Annex 1 Responses to Information Requirements

Federal Indigenous Review Team (FIRT) – Denison's Responses to Information Requirements for the Wheeler River Project Environmental Impact Statement

Annex 1 – FIRT IR Table – Technical Review of the **Wheeler River Project** draft EIS Denison Response - August 18, 2023

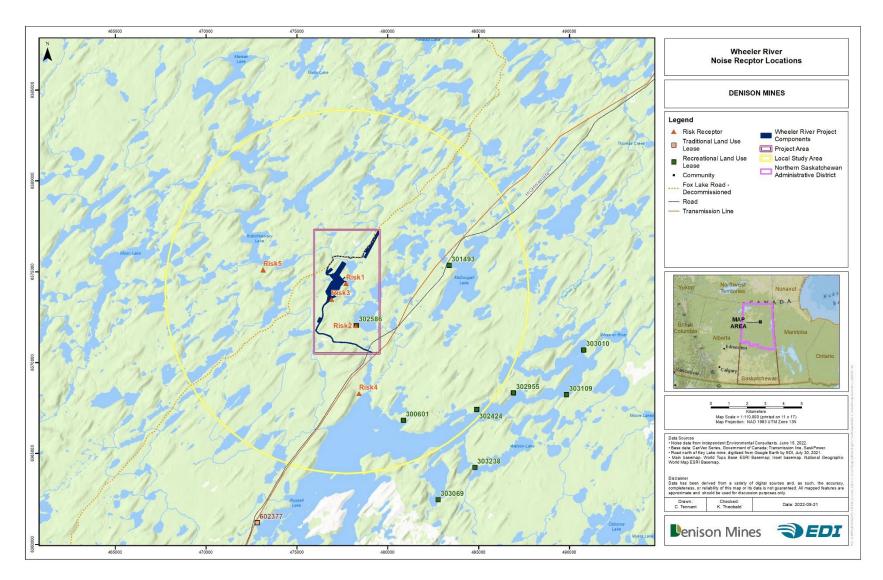
IR-48	HC	Physical stressors (noise and vibration)	Appendix 6-E, Figure 6.2.3, p. 6- 57	Noise-sensitive receptors are not included on noise contour maps.Context: Noise-sensitive receptors are identified in the acoustic model report in Section 6 Appendix 6-E but not presented on any maps in the atmospheric and acoustic sections of the main report (Figure 6.2-3).Rationale: The noise assessment typically includes a map illustrating modelled noise levels from the project at receptor locations in the study area.Certainty regarding the presence of human receptors in the regional study area is also recommended in order to assess cumulative impacts.	1. For more clarity, identify noise-sensitive receptors on Figure 6.2-3: Noise Assessment Study Area as well as on contour maps showing the baseline and predicted noise levels.	 A new figure will be added to Section 6.2 of the final EIS showing the Project Area, Local Study Area, the receptor locations, and nearby land leases (both traditional and recreational). A copy of this new figure has been included with this IR response. As noted in the context and rationale for this IR, Denison included the receptor locations on the contour maps with the predicted noise levels (Appendix 6-E, Figures 8 to 15); as such, no edits to the Appendix 6-E figures are proposed in response to this IR. 	A new figure will be added to Section 6.2 and a copy of the figure has been included with this IR response in Attachment: IR-48. The new EIS Figure will be 6.2-4; figure numbering will shift and Figure 6.2.4 Baseline Monitoring Locations for Noise in the draft EIS will become Figure 6.2.5 in the final EIS.

Number	IR-48
Dept.	НС
Project effects link	Physical stressors (noise and vibration)
Reference to EIS, appendices, or supporting documentation	Appendix 6-E, Figure 6.2.3, p. 6-57
Context and Rationale	Noise-sensitive receptors are not included on noise contour maps.
	Context: Noise-sensitive receptors are identified in the acoustic model report in Section 6 Appendix 6-E but not presented on any maps in the atmospheric and acoustic sections of the main report (Figure 6.2-3).
	Rationale: The noise assessment typically includes a map illustrating modelled noise levels from the project at receptor locations in the study area.
	Certainty regarding the presence of human receptors in the regional study area is also recommended in order to assess cumulative impacts.
Information Requirement	1. For more clarity, identify noise-sensitive receptors on Figure 6.2-3: Noise Assessment Study Area as well as on contour maps showing the baseline and predicted noise levels.

Supporting figure to the response provided in IR table:

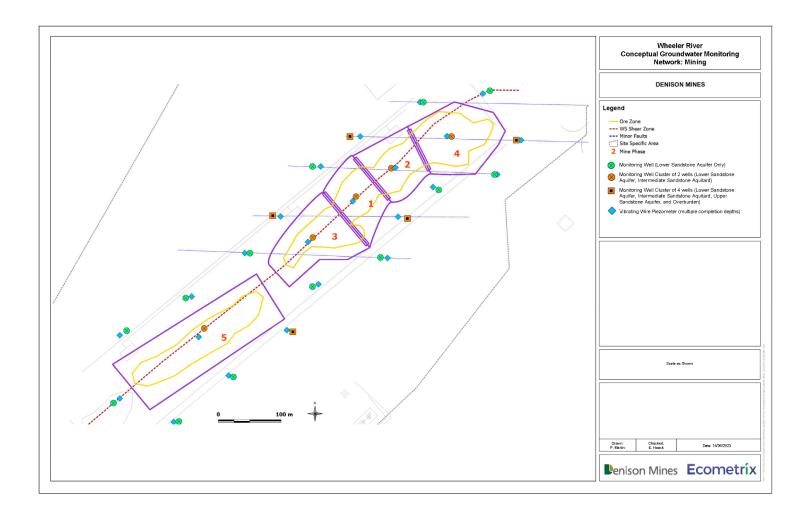
Number	IR-51
Dept.	CNSC
Project effects link	Geology and Groundwater
Reference to EIS, appendices, or supporting documentation	Section 7, Figure 7.8-1
uocumentation	Appendix 7-C
Context and Rationale	Context: Figure 7.8-1 (p. 7-107, main EIS report) shows monitoring well cluster outside of the freeze wall.
	Rationale: It is not clear what the targeted hydro-stratigraphic units of each monitoring well cluster are. In addition, it is not clear how the establishment of the freeze wall and any leakage from the brine solution will be monitored. If there is any "window" within the freeze wall (i.e., the freeze wall is not continuous), is there any way to identify that?
Information Requirement	Please clarify the targeted hydro-stratigraphic units of each monitoring well cluster in Figure 7.8-1 (p. 7-107, main EIS report).
	Please clarify how the establishment of a continuous freeze wall will be monitored.

Supporting figure to the response provided in table:

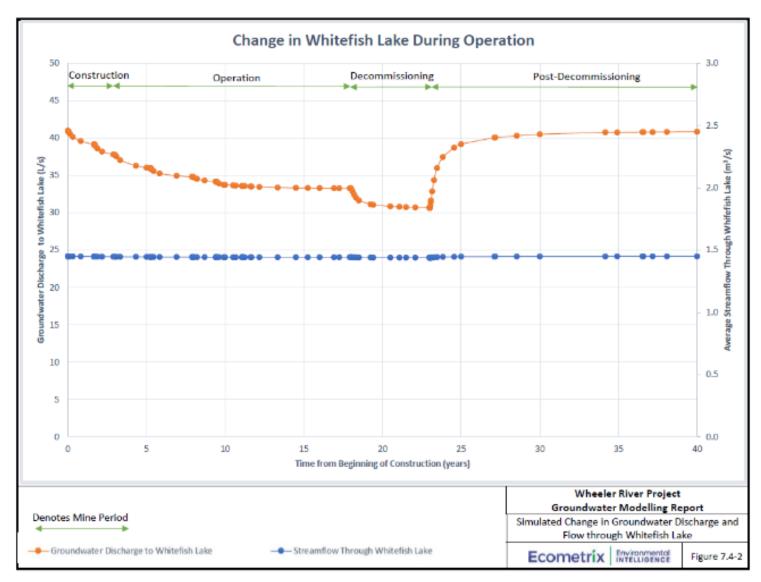
Number	IR-59
Dept.	CNSC
Project effects link	Fish and fish habitat
Reference to EIS, appendices, or supporting documentation	Section 7.4 Assessment of Project-related Effects, Figure 7.4-2 (p. 7-56)
Context and Rationale	 Context: Figure 7.4-2: Simulated Change in Groundwater Discharge and Flow through Whitefish Lake Over the Life of the Project appears to be missing information. Rationale: Legend is included below the image, but the Legend box is blank. The green dotted line is not represented by anything in the legend.
Information Requirement	Please update this Figure to ensure it is complete, and that features are properly indicated in the legend.

Supporting figure to the response provided in table:

Figure 26: Hydrochemical Type: Groundwaters for the Wheeler River Project

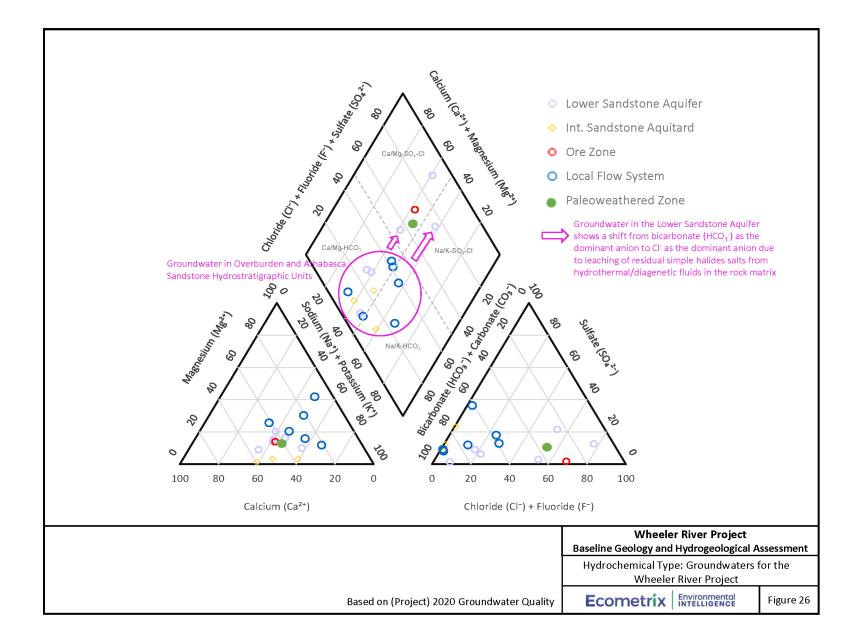
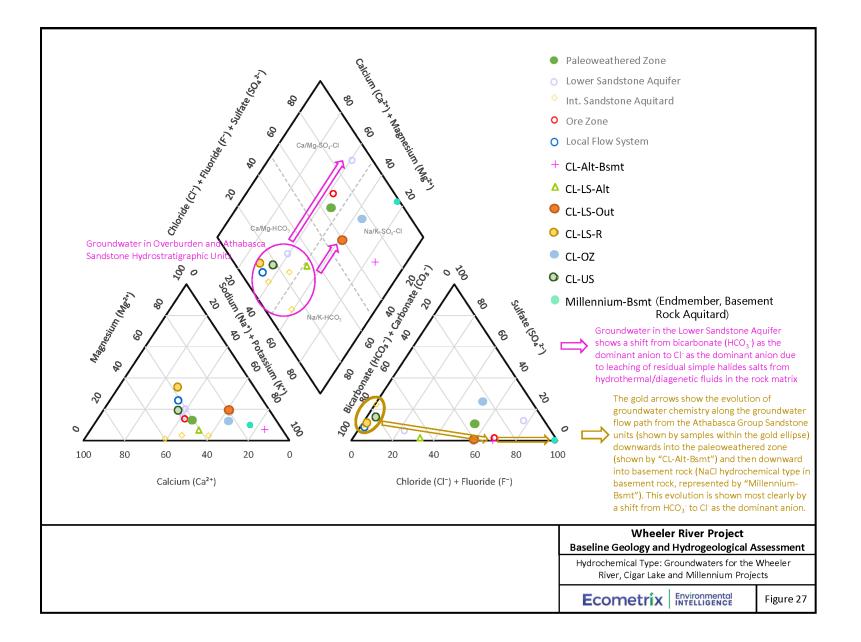
Information	Please provide additional clarity to and interpretation of Figure 26 in Appendix 7-A,
Requirement	including a revision to the Figure to allow for easier interpretation. This could include clear identification of end members, as well as arrows indicating proposed evolution of groundwater chemistry. Further discussion should be provided describing observed differences between groundwater chemistry at the Phoenix project compared to Millenium/Cigar Lake.

Figure 26 of the draft EIS was presented as two panels (panel "a" and panel "b") in Appendix 7-A to the EIS. To support visual clarity and additional interpretation, Figure 26 has been split into two figures:

The revised Figures 26 and 27 are provided below. The figures have been updated to include visual support on the Piper plots to the interpretations of groundwater chemistry that are detailed in Section 4.3.3 of Appendix 7-A of the EIS. In addition, the text in Section 4.3.3. of Appendix 7-A of the ESI will be updated to provide additional clarity on the interpretations shown in the Piper plots. The new text is provided herebelow with additions shown in blue.

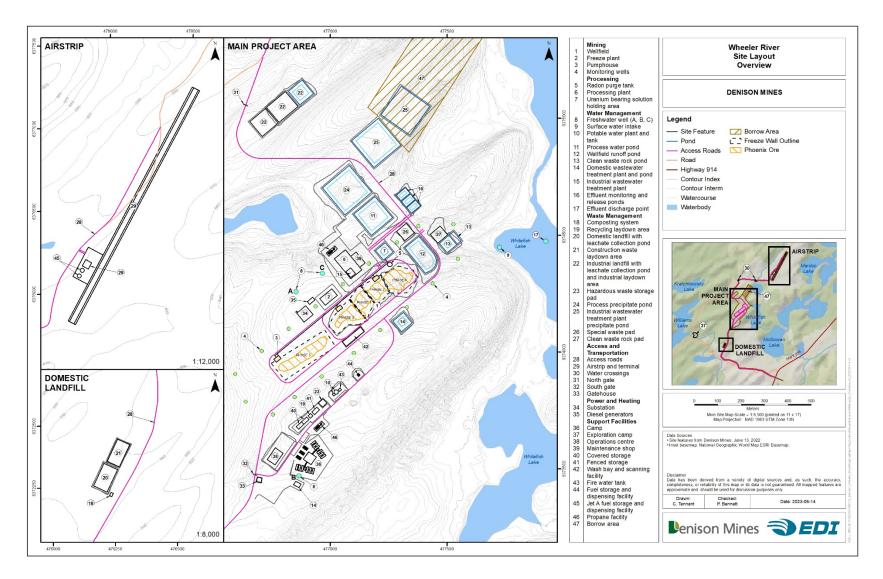
85	CNSC	Geology and Groundwater	Appendix 7-C	 Context: Section 2.7.3 (Appendix 7-C) mentions Wells A, B and C, and Figure 2-17 (p. 2.43, Appendix 7-C) illustrates the predicted drawdown ranges at Well B and Well C. Rationale: It is not clear where Well A, Well B and Well C are located. 	Please provide the locations of Well A, Well B and Well C illustrated in a Figure.	These three wells (referred within Appendix 7-C as "A", "B", and "C") are proposed wells to supply water to the mining operations. They are not yet constructed but are planned to be screened within the Upper Sandstone Aquifer. These wells were demarcated as "Freshwater wells" in Figure 2.2-1 of Section 2 of the EIS but were not labelled. Well A is located 200m northwest of the Phase 5 ISR injection area, Well B is located approximately 600 m south of the Phase 5 ISR injection area, while Well C is located 200 m northwest of the Phase 3 ISR	Figure 2.2-1 has been updated to label the "Freshwater wells" as "A", "B", and "C". The updated figure is included in Attachment IR-85 and will replace the existing Figure 2.2-1 in the final EIS.

Number	IR-85
Dept.	CNSC
Project effects link	Geology and Groundwater
Reference to EIS, appendices, or supporting documentation	Appendix 7-C
Context and Rationale	Context: Section 2.7.3 (Appendix 7-C) mentions Wells A, B and C, and Figure 2-17 (p. 2.43, Appendix 7-C) illustrates the predicted drawdown ranges at Well B and Well C. Rationale: It is not clear where Well A, Well B and Well C are located.
Information Requirement	Please provide the locations of Well A, Well B and Well C illustrated in a Figure.

Supporting figure to the response provided in table:

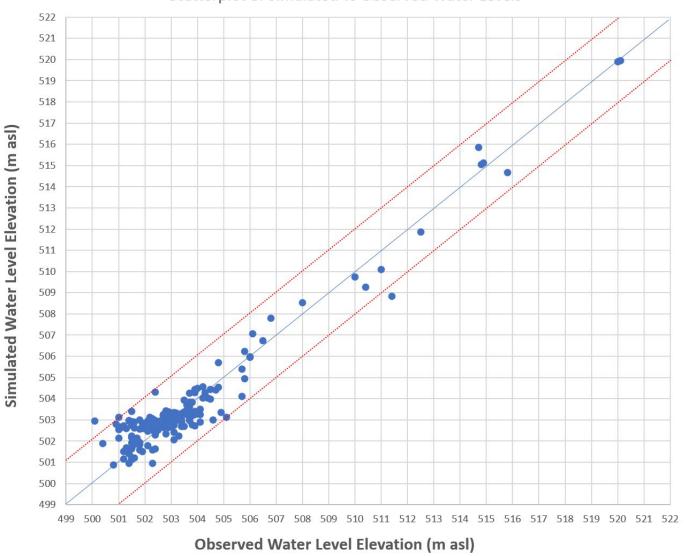
IR-91	NRCan	Fish and fish habitat	Appendix 7-C, section 2.5.2	 Context: The numerical model calibration quality plot (Appendix 7-C, sec. 2.5.2.1, Figure 2-13) contains a small error. The vertical (simulated heads) and horizontal (observed heads) axes do not have the same scales (499 to 521 masl versus 499 to 522 masl). Therefore, the line of ideal fit is offset. Rationale: As a result, NRCan notes that observed heads in the 510-512 masl range are underpredicted by the model. NRCan also notes that the calibration statistics (Appendix 7-C, sec.2.5.2.3) are highly leveraged by two data points from open boreholes south of Kratchkowsky Lake where simulated values are largely controlled by the nearby constant-head boundary in the Lower Sandstone aquifer (520 masl). 	The proponent should correct the scales on the axes of Figure 2-13 in Appendix 7-C. The proponent should also comment on the effect on calibration of the clustering of most observation wells in the ore zone.	The scales on Figure 2-13 of Appendix 7 have been corrected and included in Attachment IR- 91. From a regional perspective, the available groundwater levels are clustered around the Phoenix deposit. However, Denison advanced monitoring well clusters to support hydrogeologic (and hydrochemical) characterization upgradient, downgradient, and cross- gradient to the deposit. Data from all of these wells were used to calibrate the numerical model. It is acknowledged that the hydrogeologic conditions are extrapolated from the available data; this is consistent with the state of the practice.	The corrected Figure 2-13, which will be included in the final EIS, is appended as Attachment IR-91.

Number	IR-91
Dept.	NRCan
Project effects link	Fish and fish habitat
Reference to EIS, appendices, or supporting documentation	Appendix 7-C, section 2.5.2
Context and Rationale	Context: The numerical model calibration quality plot (Appendix 7-C, sec. 2.5.2.1, Figure 2-13) contains a small error. The vertical (simulated heads) and horizontal (observed heads) axes do not have the same scales (499 to 521 masl versus 499 to 522 masl). Therefore, the line of ideal fit is offset.
	Rationale: As a result, NRCan notes that observed heads in the 510-512 masl range are underpredicted by the model. NRCan also notes that the calibration statistics (Appendix 7-C, sec.2.5.2.3) are highly leveraged by two data points from open boreholes south of Kratchkowsky Lake where simulated values are largely controlled by the nearby constant-head boundary in the Lower Sandstone aquifer (520 masl).
Information Requirement	The proponent should correct the scales on the axes of Figure 2-13 in Appendix 7- C. The proponent should also comment on the effect on calibration of the clustering of most observation wells in the ore zone.

Supporting figure to the response provided in table:

Attachment IR-101 Figure 1 – Elevations of Wetland Features in the LSA.

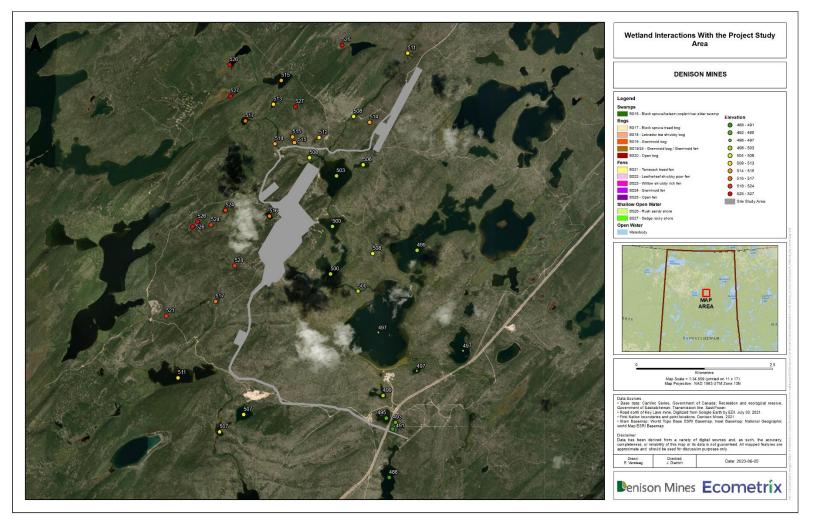
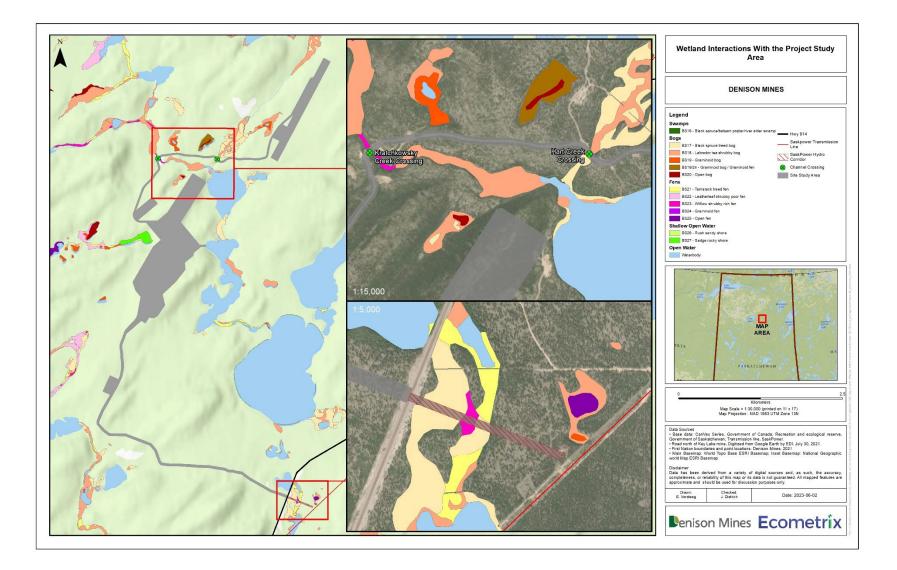
Number	IR-101
Dept.	ECCC
Project effects link	Fish and fish habitat
Reference to EIS, appendices, or supporting documentation	Section 8.1.1.3, Section 8.2.1.3 Aquatic Environment
Context and Rationale	Context: In Section 8.1.1.3 Spatial and Temporal Boundaries the Project Area, Local Study Area (LSA) and Regional Study Area (RSA) are established as they pertain to surface water quantity. The same is done in Section 8.2.1.3 for surface water quality. In Section 8.1.1.3 Figure 8.1-4, the locations of the Project Area, LSA, RSA and surface water features and monitoring stations are provided.
	However, the locations of wetlands located near the Project area and within the LSA and RSA have not been provided. The location of wetlands within or near the Project footprint, as well as the other wetlands existing within the LSA can be confirmed from Part II_S9 Terrestrial Environment, Section 9.2.3.3 Figure 9.28, including the wetland classifications. There appears to be at least one shallow open water wetland and several bogs located within the Project Area. There is no consideration of wetlands or potential effects to wetland hydrology, surface water or sediment quality throughout the aquatic environment assessments. There is no baseline information regarding wetlands and their status as fish habitat and ecological function, or assessment of potential effects to flow rates, water levels, water quality, sediment quality, or biota.

Supporting figures to the response provided in table:

Attachment IR-143 Figure 9.3-8 Caribou Sign Observations in the Wildlife Study Areas (updated)

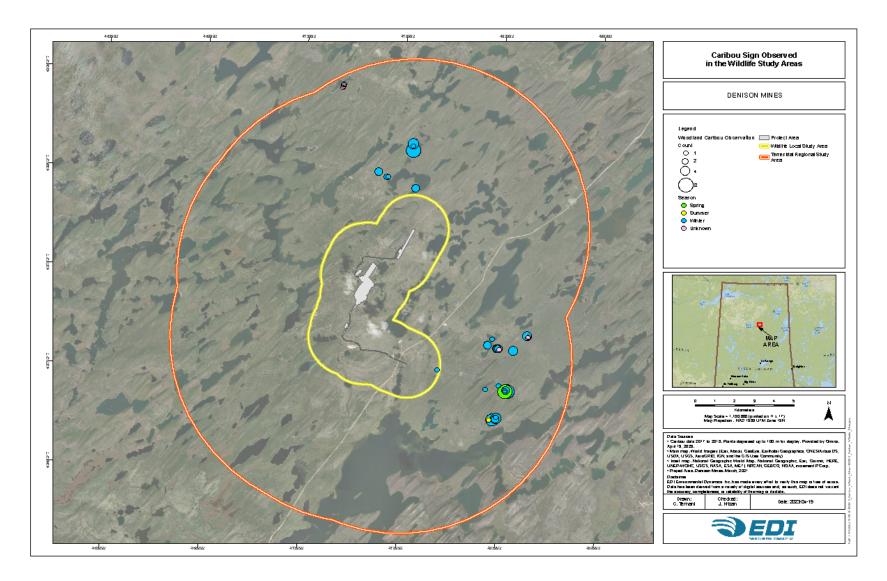
IR-144	ECCC	Wildlife and Wildlife habitat	Section 9.3.3.3, Baseline Studies – map 9.3-8	 Context and Rationale: The mapping of caribou observations during baseline studies provided in Figure 9.3-8, "Caribou Sign Observations in the Wildlife Study Areas," is insufficient to enable conclusions to be drawn. ECCC is not able to review the spatial aspect of caribou observations without a map of all available observations. Additional information is available, as stated in Section 9.3.3.3: "A total of 200 observations were made between 2017 and 2019 and recorded as either caribou sign (i.e., tracks, pellets, and evidence of feeding activity based on ground feeding craters and arboreal feeding evidence) or photographs (collected through the wildlife camera study) to document caribou presence in the LSA and RSA. Most observations occurred in the Terrestrial RSA, with observations concentrated in the north and southeast portions. Three observations occurred in the southeast portion of the Wildlife LSA, and no caribou sign was observed in the Project Area. Figure 9.3-8 provides an overview of some caribou sign observed during the baseline studies." 	Update map 9.3-8 to show all caribou observations during baseline studies, broken down by type of observation (camera, incidental, pellet, track) and season/year when the observation was made. Include additional data from the Province of Saskatchewan (see also IR-145) to help characterize caribou use on a spatial map.	 Refer to the Attachment IR-143 for the updated version of Figure 9.3-8. Denison acquired data from the Province of Saskatchewan which has been included in Attachment IR-145. As shown in the figure, the data is not available in a format that can be imported for analysis and incorporated into a spatial map. The data does not specify seasonality of the observations. Regardless, this data relates to the information provided by McLoughlin (2019 and 2021) and confirms caribou have been previously documented within the RSA, particularly in the eastern portion. References: McLoughlin, P. D. 2021. Associate Professor, University of Saskatchewan, Saskatoon, SK. Personal Communication. January 2021. McLoughlin, P. D., C. Superbie, K. Stewart, P. Tomchuk, B. Neufeld, D. Barks, T. Perry, R. Greuel, C. Regan, A. Truchon-Savard, S. Hart, J. Henkelman, and J. F. Johnstone. 2019. Population and habitat ecology of boreal caribou and their predators in the Saskatchewan Boreal Shield. Final Report. Department of Biology, University of Saskatchewan, Saskatoon. 238 pp. 	No updates to the draft EIS are needed based on this IR response.

Supporting figure to the response provided in table: revised Figure 9.3-8
